SUBMITTAL OF 07 AUGUST 2018
BY C&J GRAVEL PRODUCTS, INC.
MONTOKA PIT M1980-146
(GRANDVIEW PIT)

SUBJECT: Response to Adequacy Review of 06 July 2018, M1980-146 AM-06

Memorandum for Ms. Helen Mary Johnson, Bureau of Land Management Tres Rios Office
Subject: Response to Comments on Montoya Pit Reclamation Plan, received 28 May 2018, BLM COC 64651, as provided to C&J Gravel on 6 July 2018.

MAP B-1. MONTOYA PIT AREA MAP

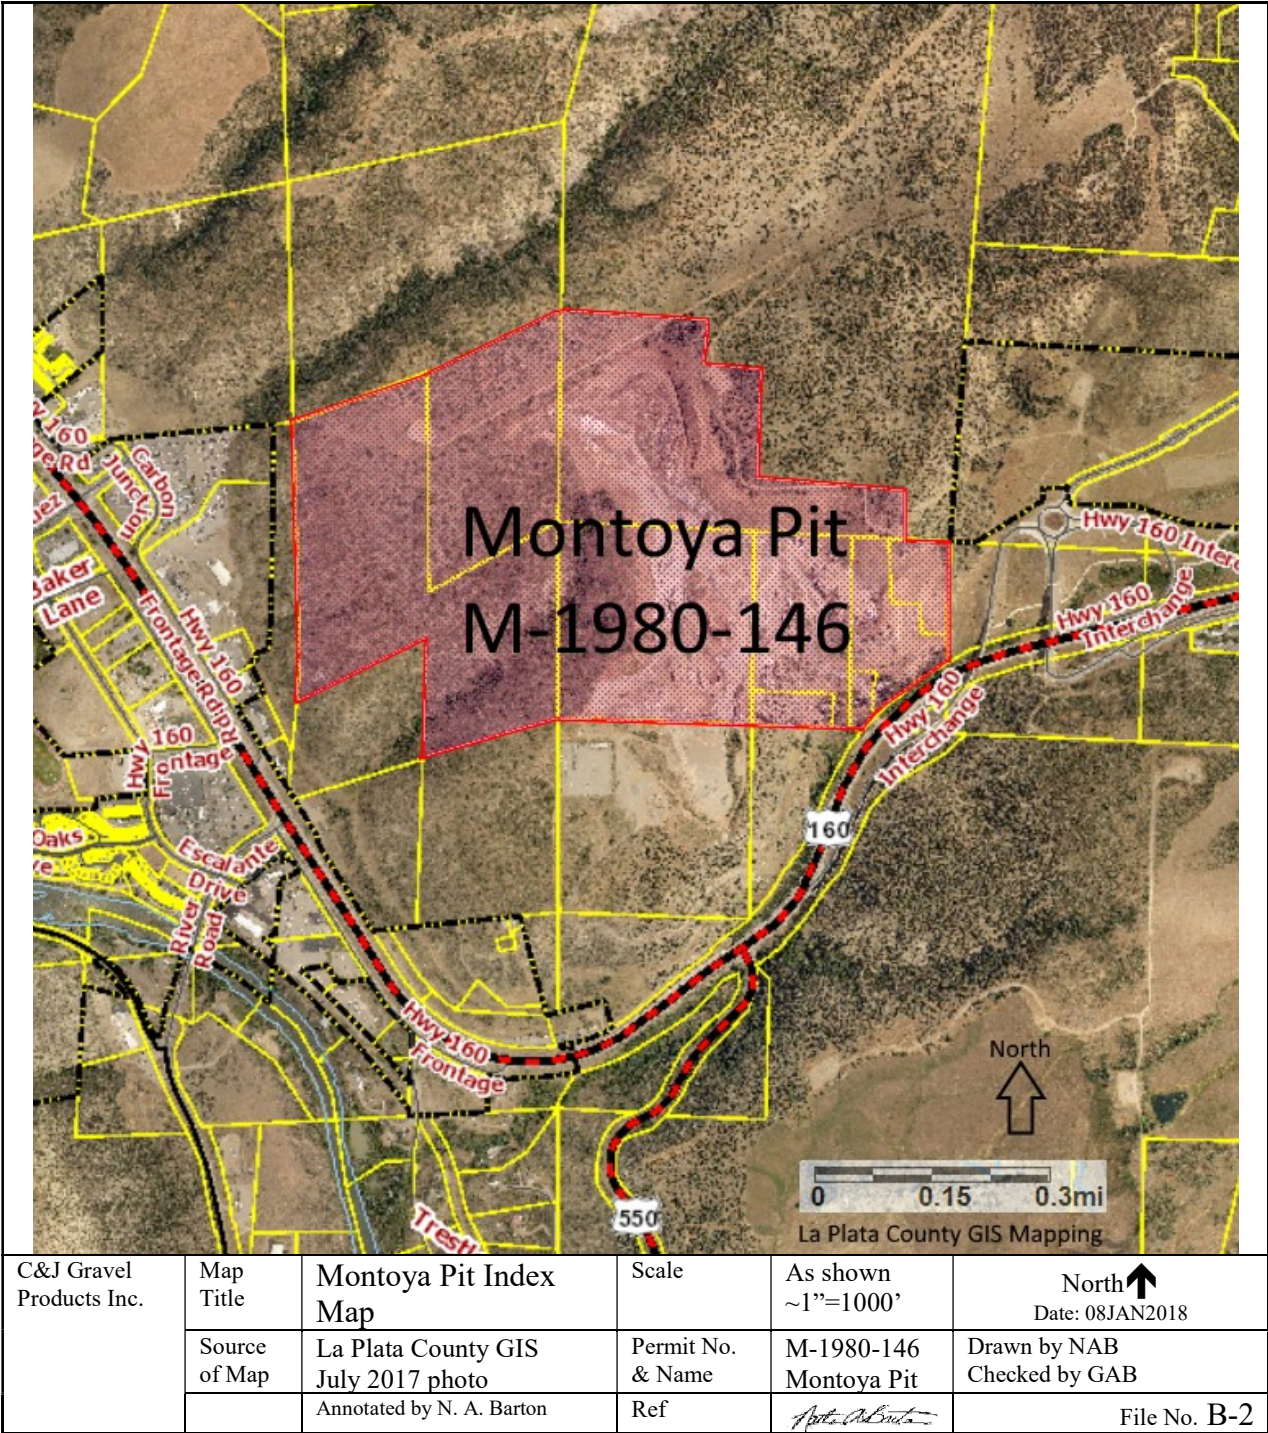
- a. Figure B-2; The map misrepresents the area that BLM intends to authorize for development at this time. The area should only include that as represented in Figure 1, above. In the future, the BLM will consider whether to authorize additional development in this area through a competitive process, depending on conditions at that time. **NO CHANGE made: There is no intent to misrepresent anything. This map is the same map provided for the last permit amendment (AM-05) in 2008-11). This map shows and is labeled to show the 112c PERMIT BOUNDARY and not the status of areas within the permit boundary, for which C&J has a right to enter or which are affected or proposed affected area. The permit boundary established in AM-05 was approved by BLM, and it is clearly stated in multiple locations and on various maps that only some areas inside the permit boundary are to be affected and for which C&J has a right-to-enter.**

Figure M-2. Surface water flow – Montoya Pit (as of Spring 2018)

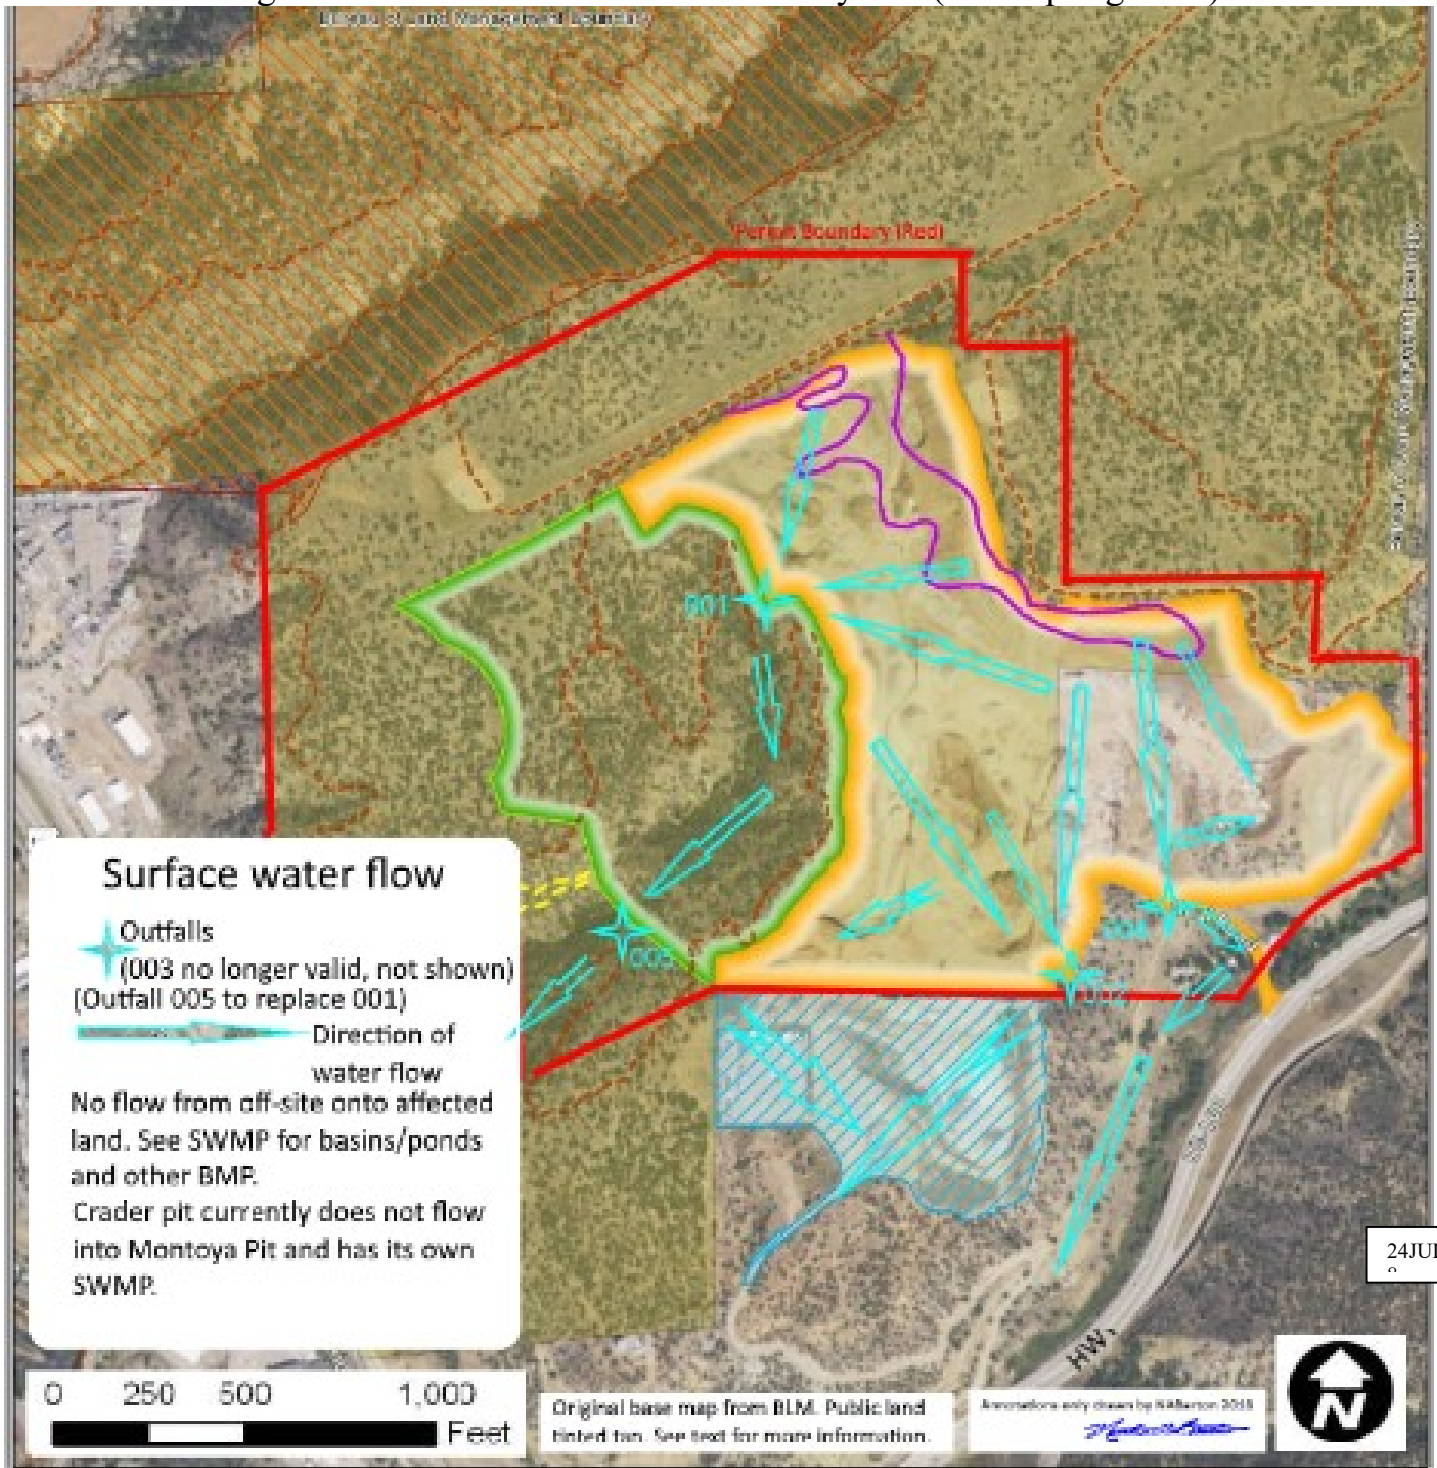
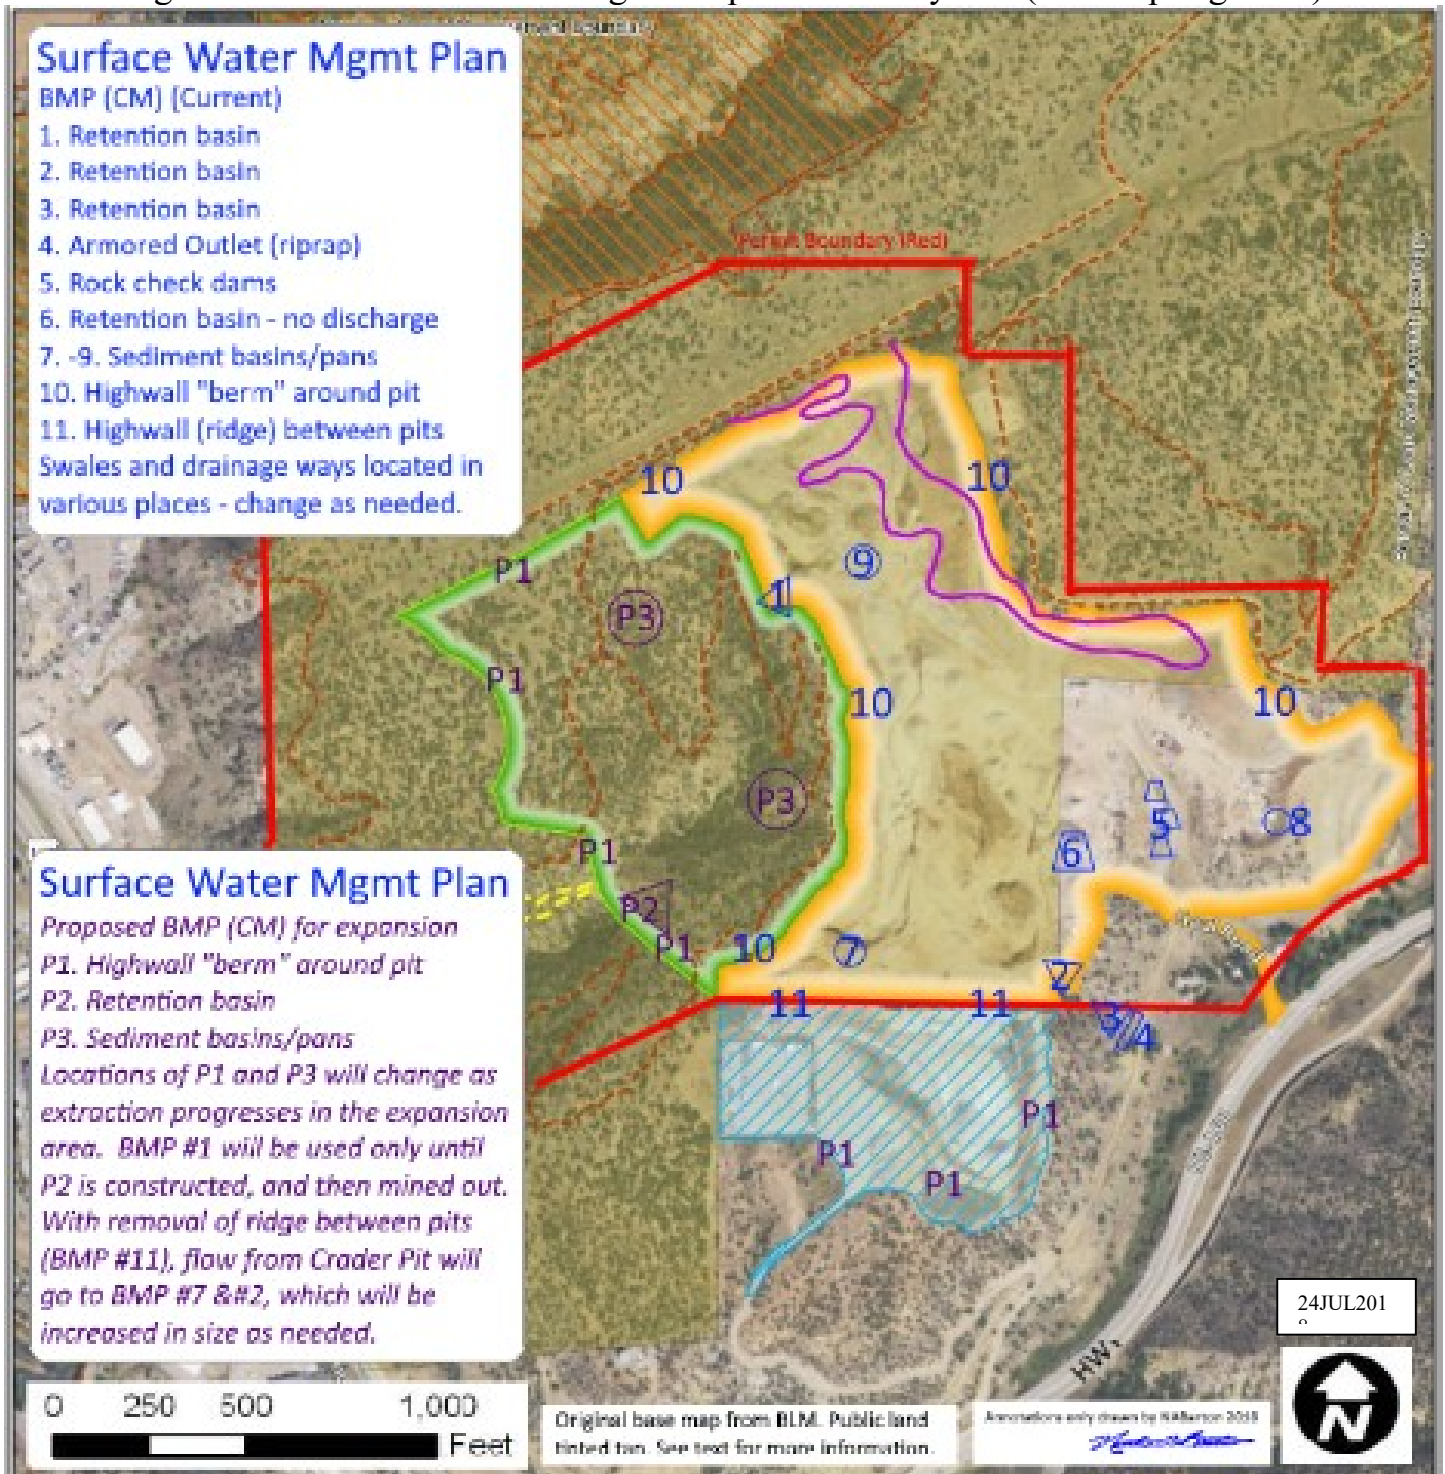
a. Item number 4 discusses that the BLM Environmental Assessment (EA) already addressed the surface flow concerns from the mining impacts in the upper portion of Sale Barn Canyon. Please include that information as well as summarize the details your storm water management plan in this Exhibit.

As discussed above, the storm water management summary, including map (modified to meet DRMS standards) is now an attachment to Exhibit M, with general information provided in Exhibit G. This information had previously been provided both to the EA preparer, BLM, and the Division. It has been modified already due to changes in the pit, and will continue to be changed as necessary as conditions change, to meet regulatory requirements of the Clean Water Act and implementing regulations, and the CPDS storm water discharge permit issued by CDPHE. Those permits are generally re-issued on a five-year cycle, and are next due in 2020.

There has been no release of reclaimed areas
REVISED FROM ANNUAL REPORT 2016-18, SHOWING LAND OWNERSHIP

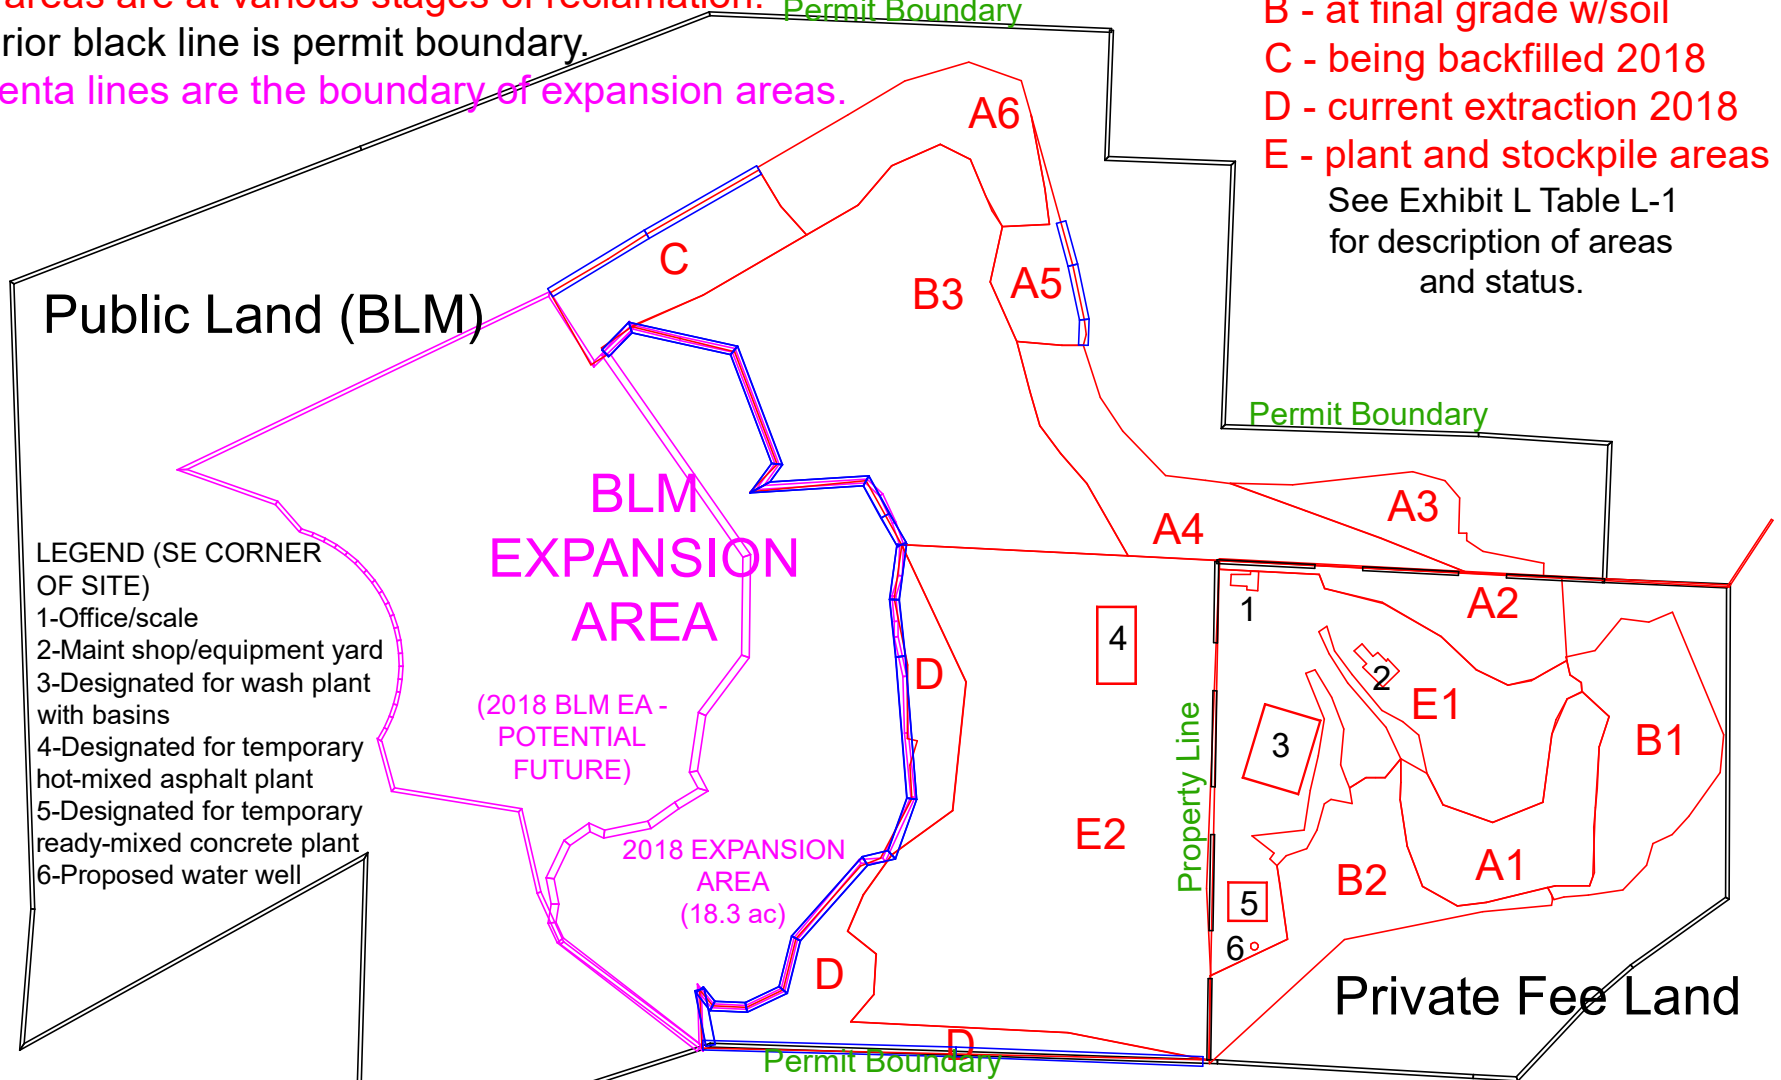
a. The reclamation plan outlines that portions of the private properties located within the permitted area are intended to change the post mining land use to Industrial / Commercial while the lands administered by the BLM will be reclaimed to support a post mining land use of Wildlife Habitat. Please submit a new map in compliance with Rule 6.2.1(2) that clearly depicts which areas will be Wildlife Habitat and which will be Industrial Commercial. These features could be included on the revised final topography map, Map F-1.

g. Figure E-1 appears to reference a map with areas such as C-3,C-4, FW, etc. That map was not submitted with this application. Please submit the map that corresponds with Figure E-1.

That information is already provided in Map C-1, which has been further annotated. All Private Lands are to be Industrial/Commercial, and all BLM-managed Lands are to be Wildlife Habitat and Recreation. We have attempted to clarify this in several other maps and exhibits as well.

Figure E-1 should probably have been labeled as Table E-1. Again the confusion was unintentional. These areas are identified on Map C-1. The lettered areas are shown in the table in the upper right corner: the number indicates the specific part of those areas, including identifying BLM and Private land. The numbers are now added to Map C-1.

TYPICAL CROSS-SECTION Looking North Across Pit Floor and 18.3-acre 2018 Expansion Area

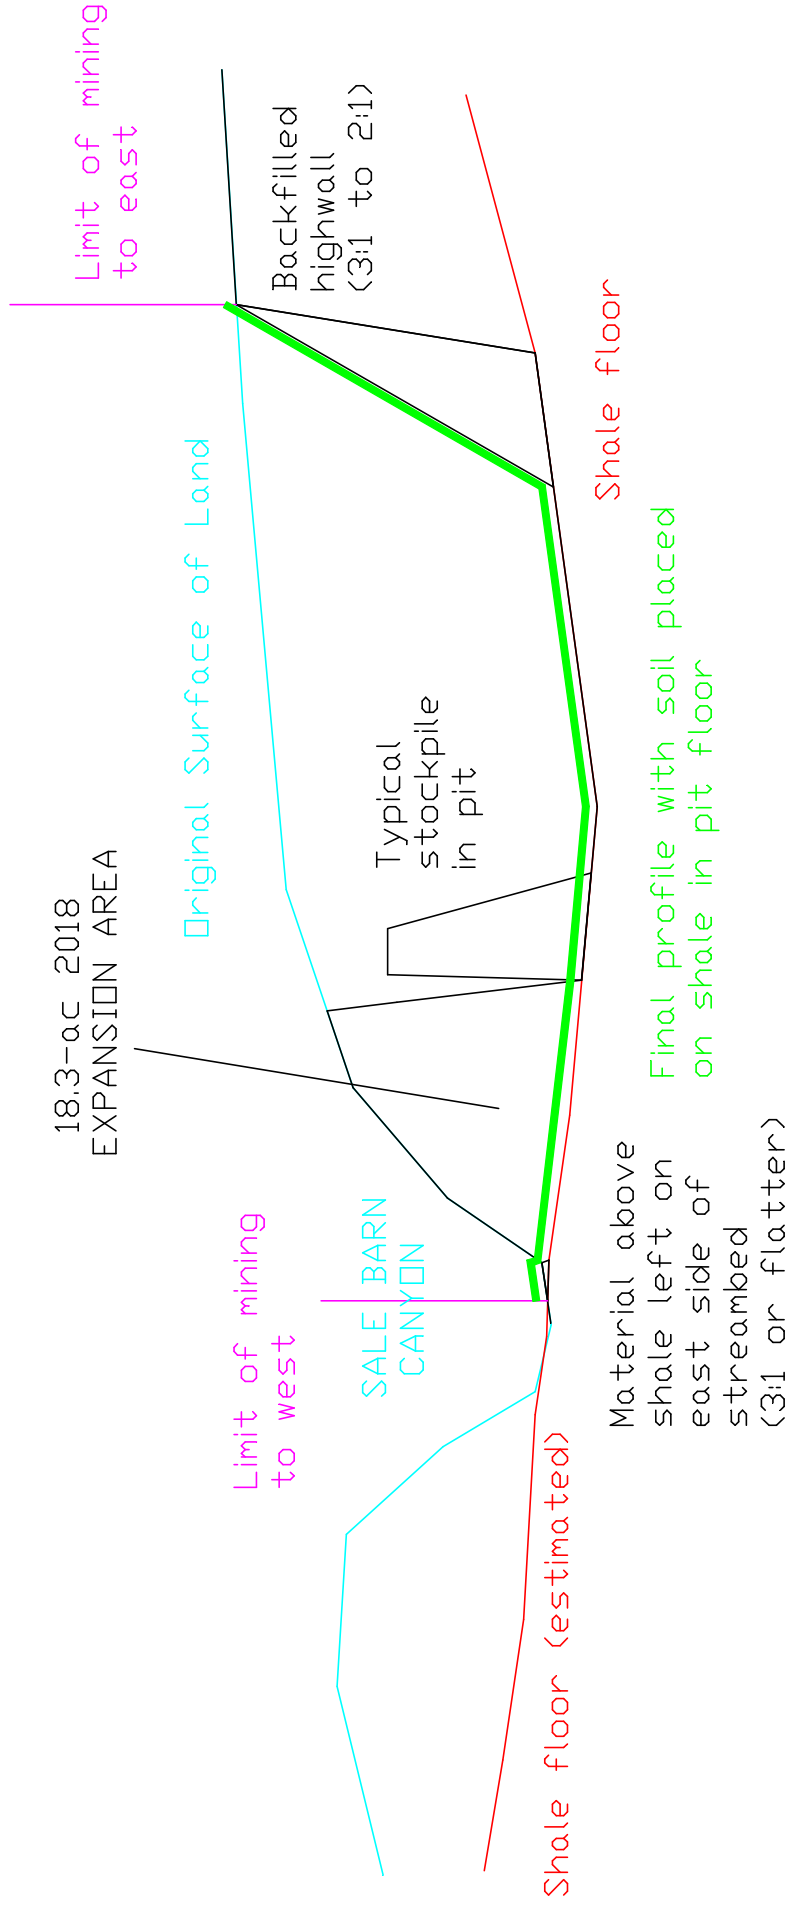
- c. Exhibit C-5; Note, C&J Gravel may apply to the BLM for an extension of an additional year. **We have added this note.**
